WestConnex M4-M5 Link

Mainline Tunnel modification

Response to submissions report

November 2018

Figure A-1 Swept path analysis at the Dobroyd Parade / Waratah Street intersection

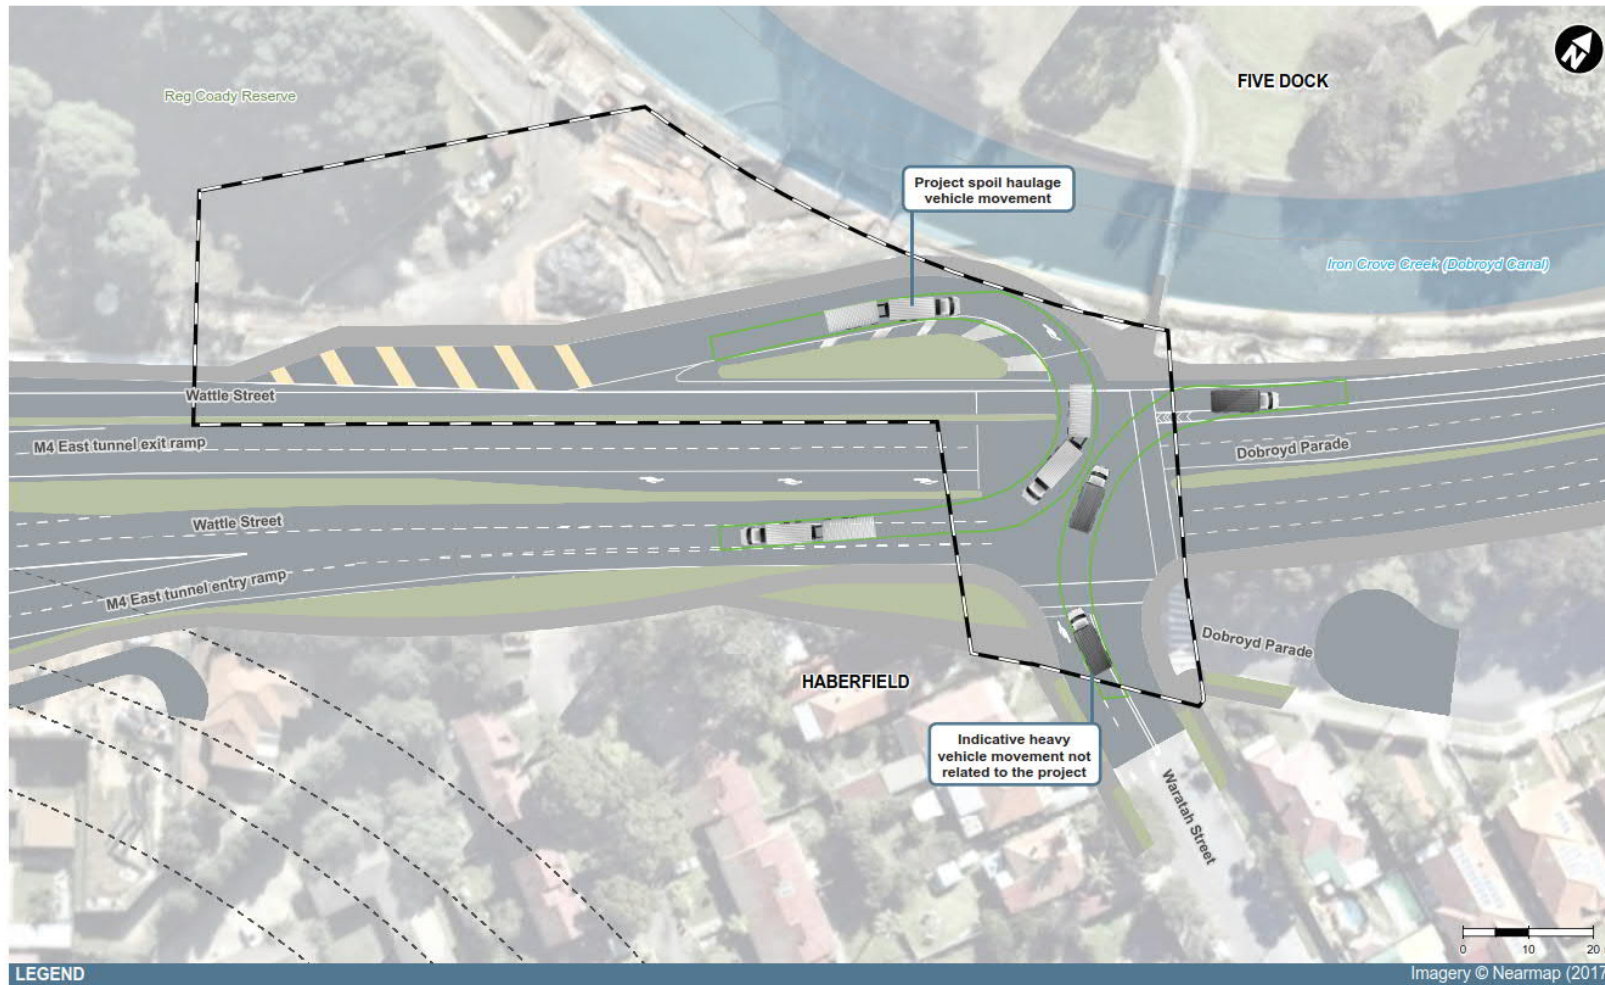
Figure 4-3 in Appendix B (Traffic and transport report) of the Modification report provides a swept path analysis at the Dobroyd Parade / Waratah Street intersection for a spoil haulage vehicle (truck and dog) exiting the G-loop and turning right onto Dobroyd Parade. The figure also showed a swept path for a heavy vehicle exiting Waratah Street and turning right onto Dobroyd Parade.

In Appendix B Figure 4-3, the swept path diagrams for spoil truck routes are noted, but it is questioned why a swept path has been shown for trucks exiting Waratah St to Dobroyd Parade when this is not a spoil haulage route.

There are no spoil haulage vehicle movements proposed into or out of Waratah Street as part of the proposed modification.

Figure 4-3 in Appendix B (Traffic and transport report) of the Modification report has been amended in **Figure A-1**.

Figure 4-3 in Appendix B (Traffic and transport report) of the Modification report has been amended and the correct detail is shown in **Figure A-1**. This has been included as a clarification in **section A4.1.1**.
